Leveraging Risk Insights in Aging Management

June 2, 2022

Risk Insights for Aging Management

EPRI Preventive Maintenance Basis Database Vulnerability Result

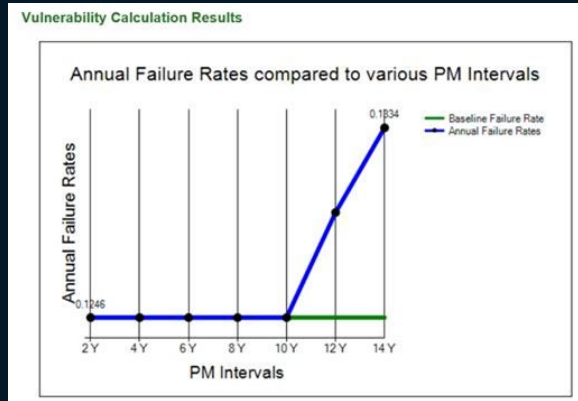
- NEI is proposing to increase the testing frequency by approximately 66% using two relatively undefined data points.
- Explain how using only two data points can establish a meaningful trend to inform changes to testing frequency.

- EPRI PMBD vulnerability study indicates no increased failure rate for cables unless the test frequency is > a 10-year test period.
- EPRI review of industry test data since 2009 had no instances of long-term wetted cables failing when tested on a 6-year frequency, and very cables that tested “good” did not test less than “good” on subsequent tests.
